Re: In the Matter of the Proposed Listing
of Richardson Flat Tailings, Summit
County, Utah, on the National Priorities
List (Update 7)

IN THE MATTER OF THE PROPOSED)	COMMENTS OF UNITED PARK
LISTING OF RICHARDSON FLAT)	CITY MINES COMPANY IN
TAILINGS, SUMMIT COUNTY, UTAH,)	OPPOSITION TO PROPOSED
ON THE NATIONAL PRIORITIES LIST)	RULE

MAP 1

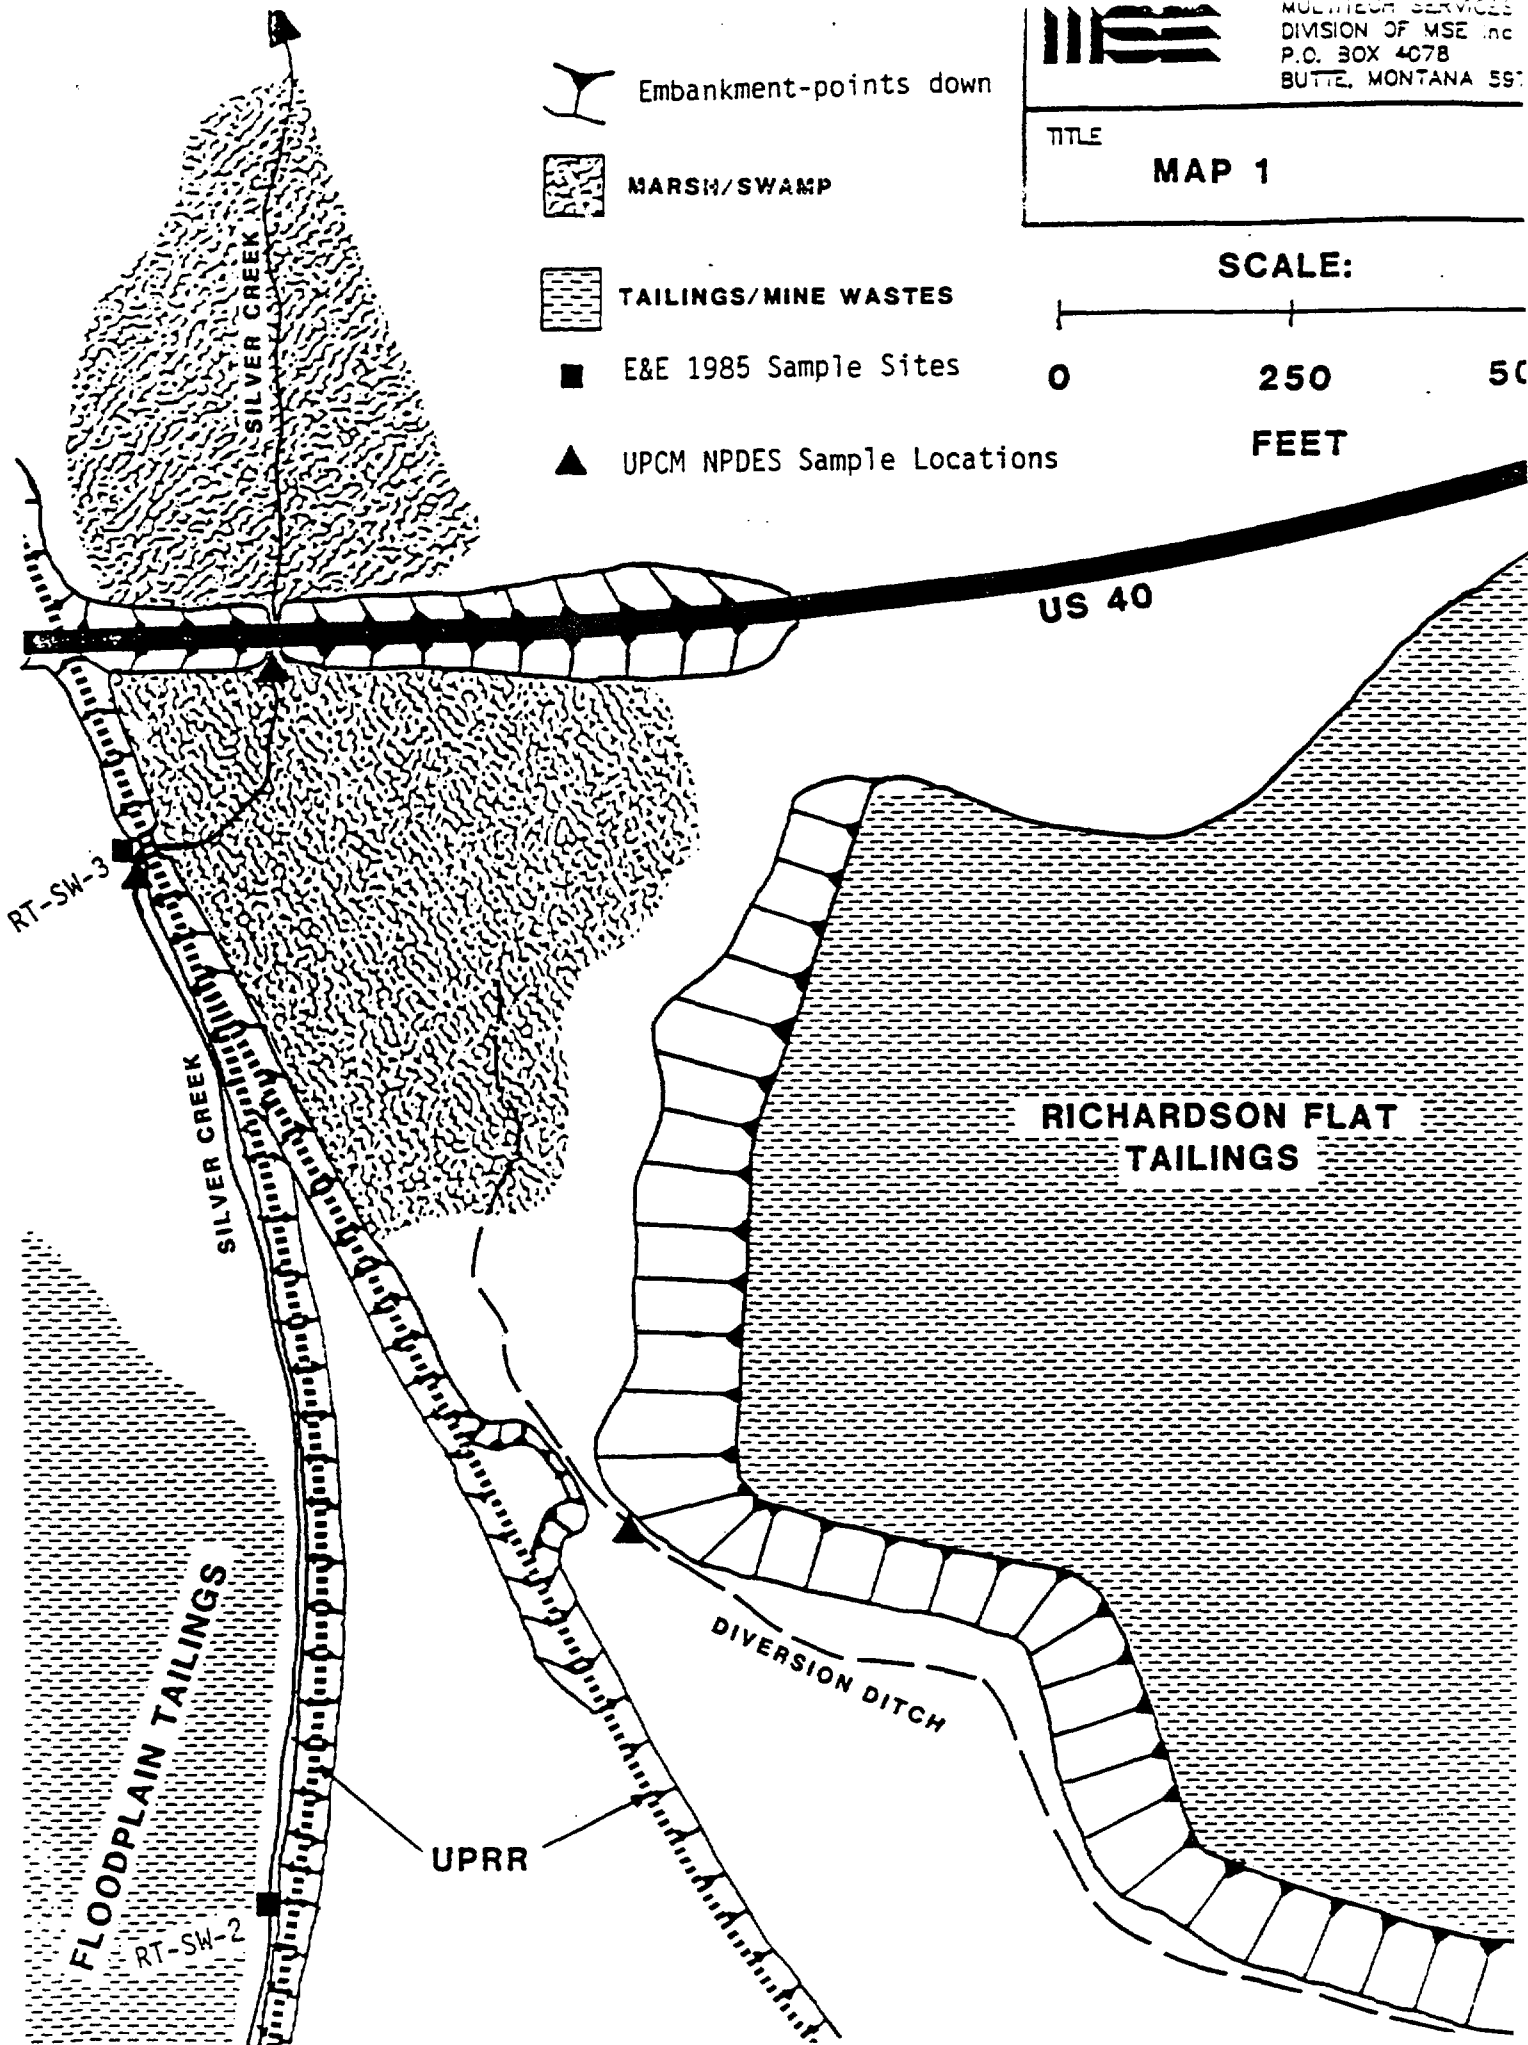
The score for Observed Release for the Surface Water Route should be 0 because no release is demonstrated by the data collected during June 1985 by EPA's contractor E&E. The sample listed as downgradient (RT-SW-3) was collected at the railroad

trestle at Keetley Junction, as per Figure 2 of both the Analytical Results Report and the Report of Sampling Activities, telephone communication of August 8, 1985 between Ms. Sue Kennedy of E&E and Kerry Gee, United Park, and as described on the Chain of Custody Record (attached hereto as Exhibit "A") given to United Park for its splits of samples received on June 20, 1985. This location is, in fact, upgradient from any hydrologic influence of the Richardson Flat tailings (see Map 1 attached hereto). The map (Figure 2) provided in E&E's Report of Sampling Activities and Analytic Results is grossly in error and Map 1, attached hereto, illustrates the correct hydrologic and spatial relationships in question.

United Park is required, under its National Pollutant Discharge Elimination System ("NPDES") permit to sample Silver Creek at an upgradient and a downgradient location from the Richardson Flat tailings. In addition, United Park is to sample the man-made diversion ditch that diverts natural runoff water around the pond. These have been Utah State Health Department requirements of each NPDES permit issued to the operators of the Richardson Flat Tailings Pond since the first permit was issued to Park City Ventures in 1975. These were also some of the original conditions under which the tailings pond was approved by the State of Utah in 1974 (See Construction Permit attached hereto as

MAP 2

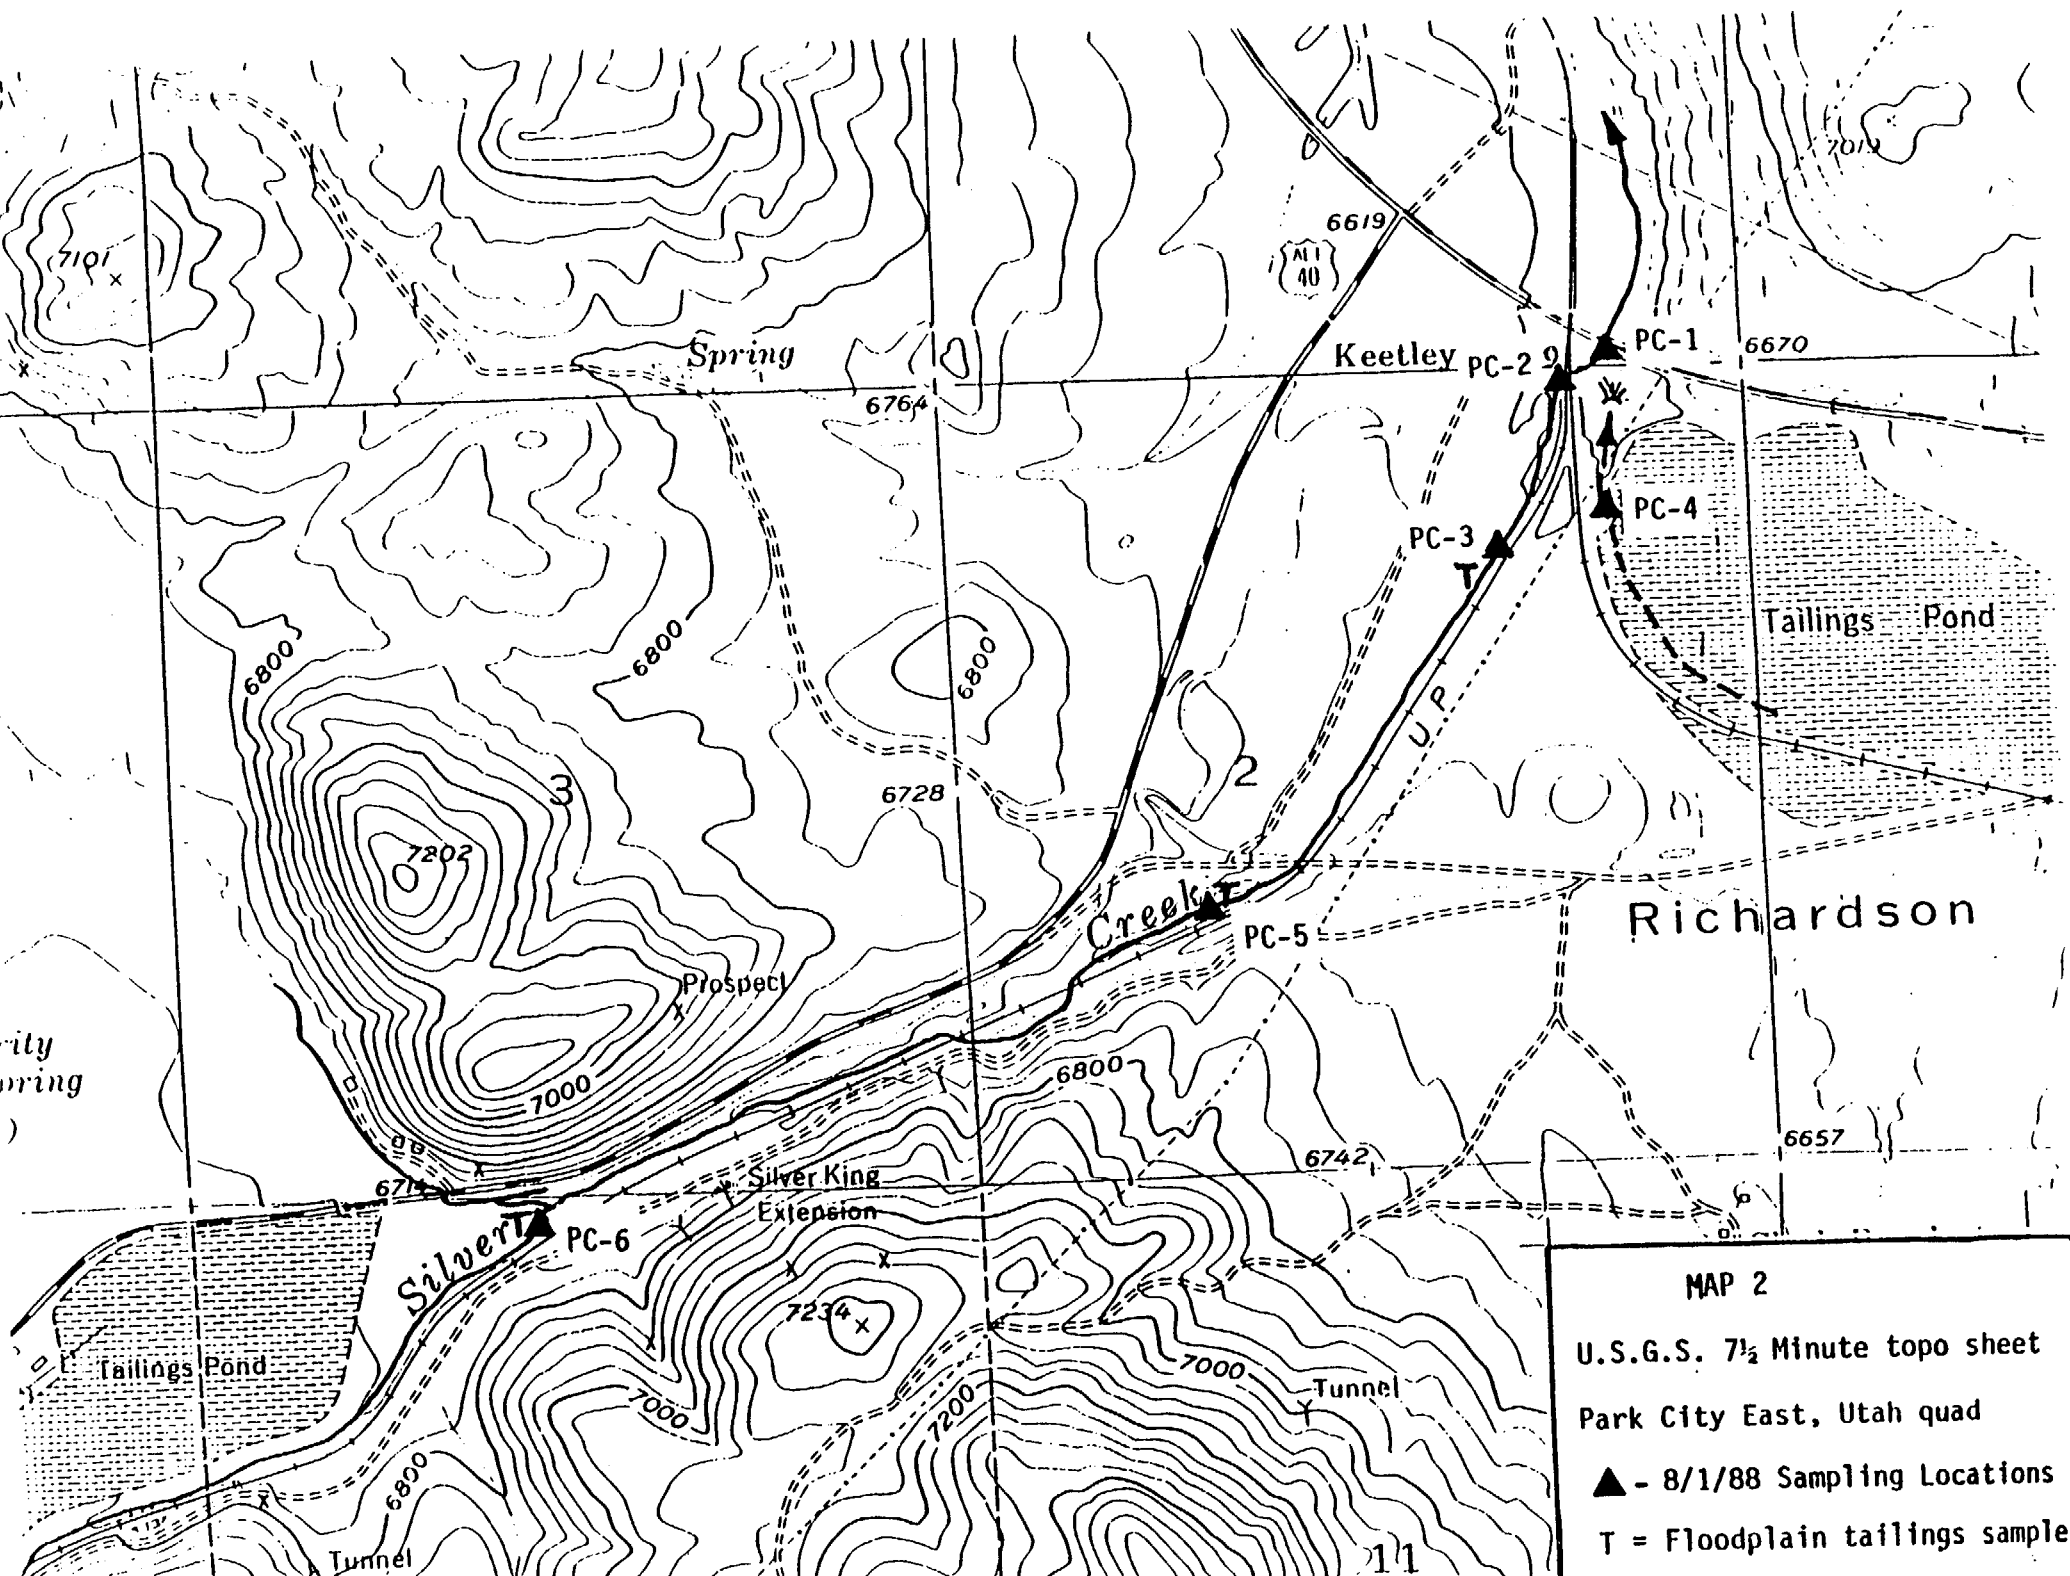
MSE's samples, as discussed in MSE's attached Report and Tables 3-5, show that stream sediment is derived from Prospector Square tailings. MSE's stream sediment samples also

clearly demonstrate a decay of metal concentrations with distance from Prospector Square tailings.

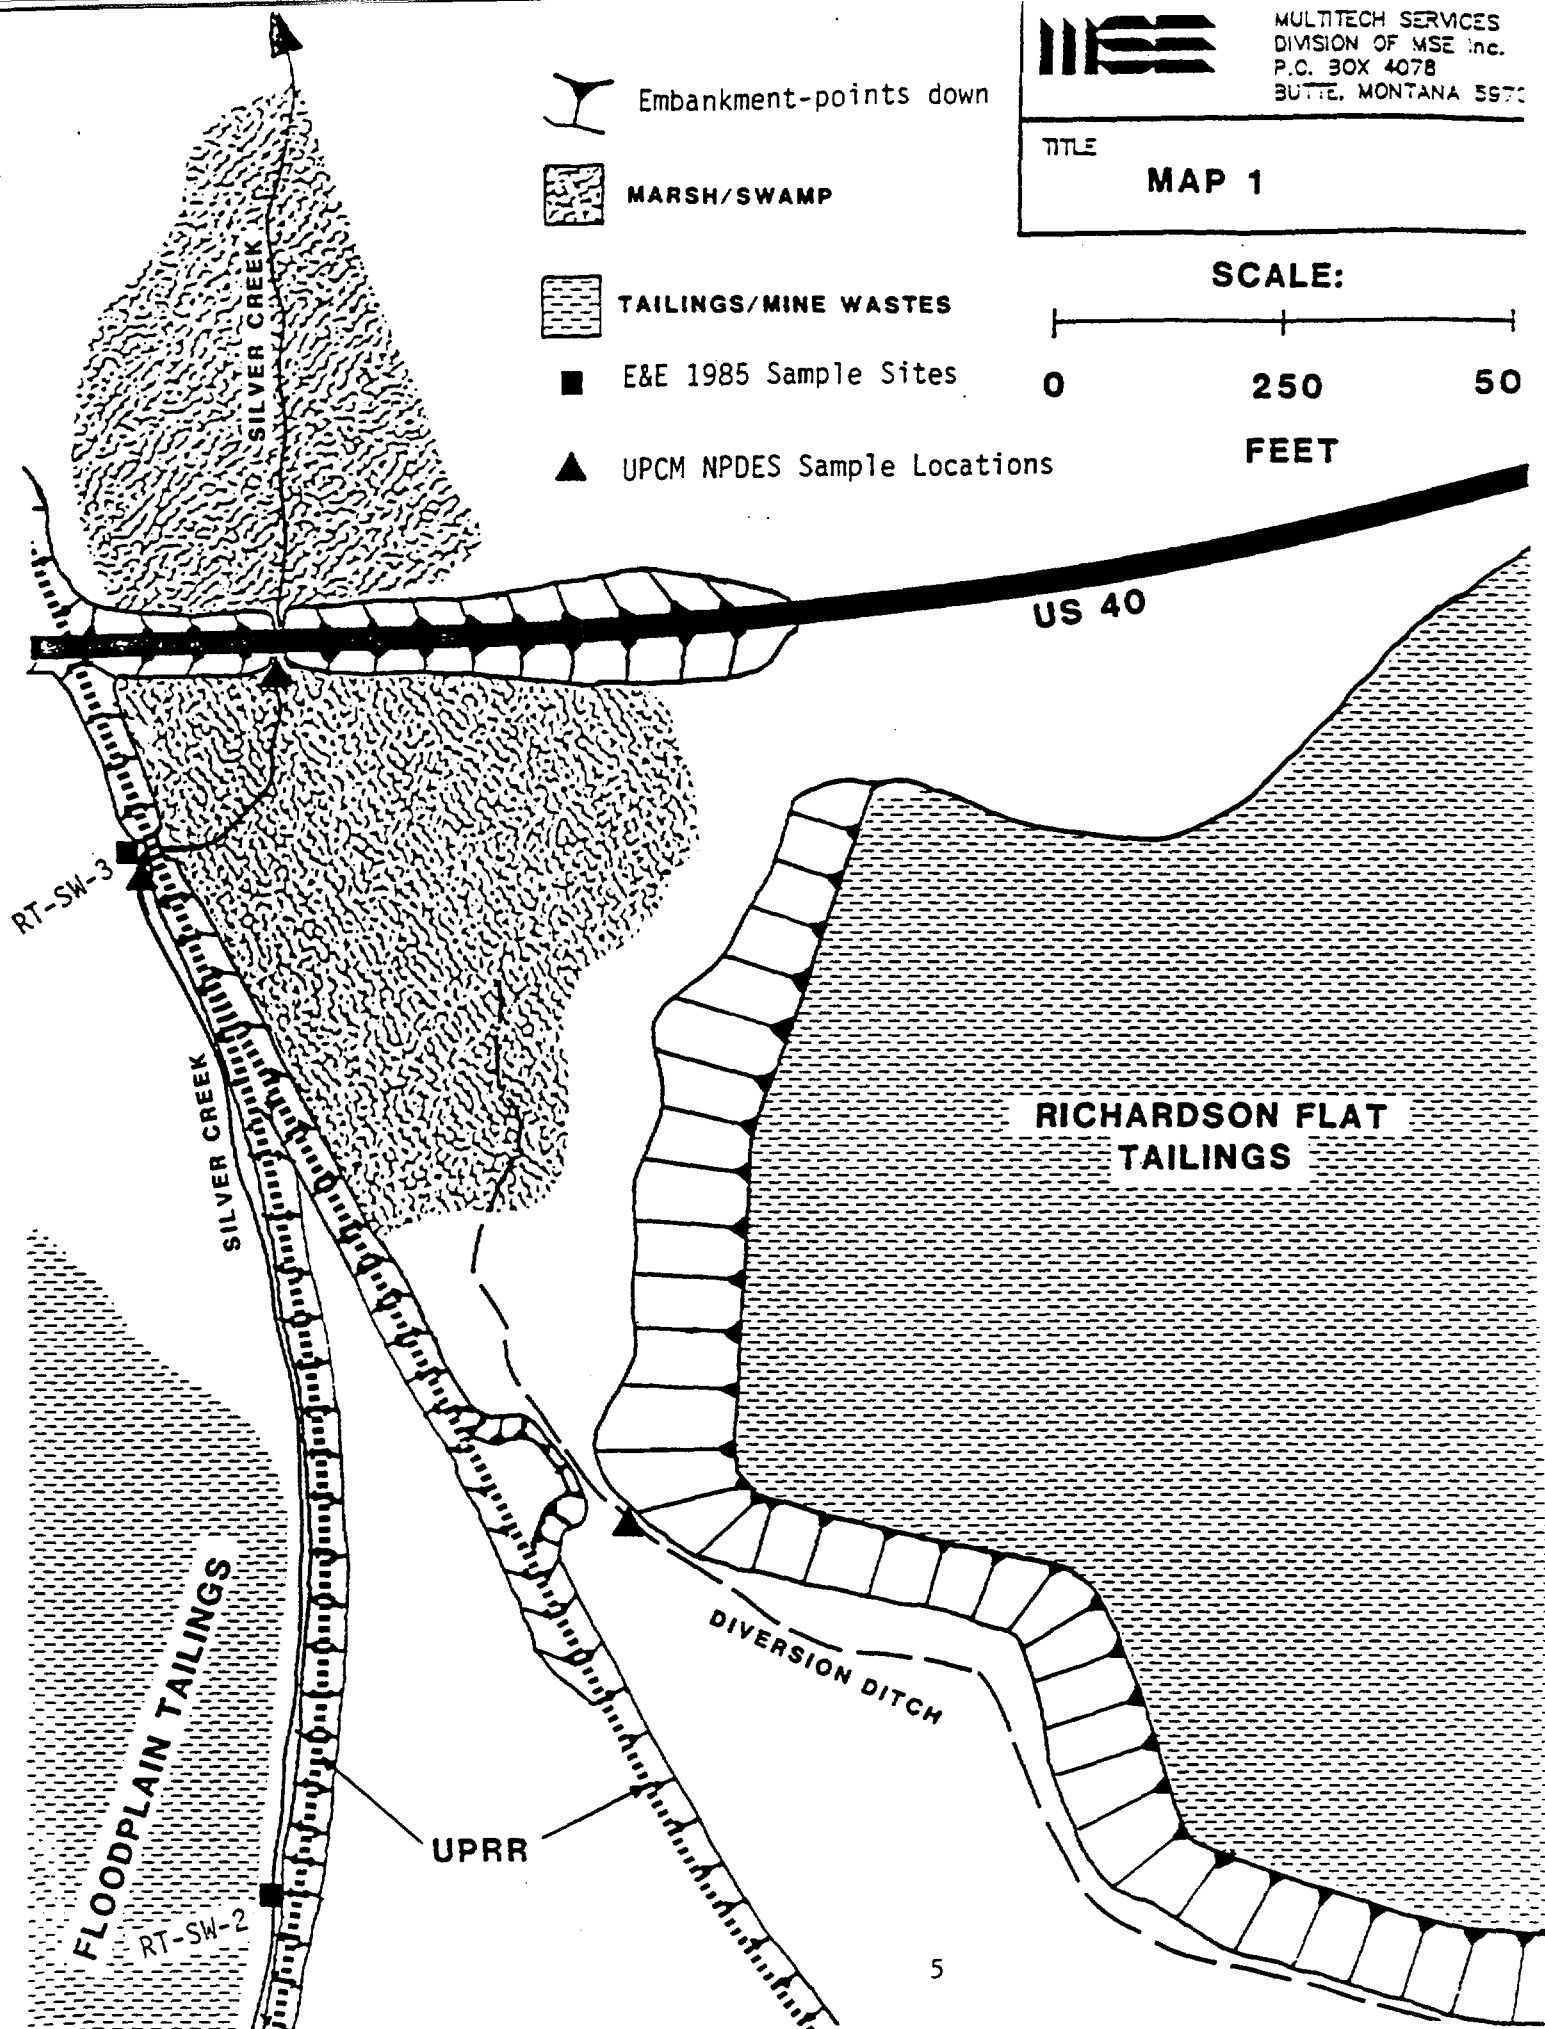
This score should be 0 since no release has been demonstrated by the data collected during July 1985 by Ecology & Environment (E&E). The sample listed as downgradient (RT-SV-3) was collected at the railroad trestle, per the location map in the Sampling Activities Report, the chain-of-custody forms, and communication with Ms. Sue Kennedy of E&E. This location is, in fact, upgradient from any hydrologic influence of the Richardson Flat tailings (see Map 1). The map provided in E&E's report is grossly in error, and Map 1 illustrates the correct hydrologic and spatial relationships in question. The "downgradient" sample site at the railroad trestle corresponds to United Park City Mines' upgradient NPDES sampling location. As shown on Map 1, any influence from Richardson Flat tailings would enter Silver Creek between the railroad trestle and the culvert under US 40. Any influences from either the diversion ditch through the tailings or seepage beneath the tailings dam would be confined to the marsh between the railroad grade and the highway embankment. The correct sampling locations to measure possible releases from the Richardson Flat tailings correspond to those regularly sampled for NPDES requirements, that is: upstream sample at the railroad trestle and downstream sample at the culvert under US-40. These locations have been regularly sampled since 1977 and analyzed for Total Pb, Mn and Hg. NPDES data are summarized in Table 1, lead is the only element presented since Hg was almost always below detection and Mn is not listed as an element of concern.
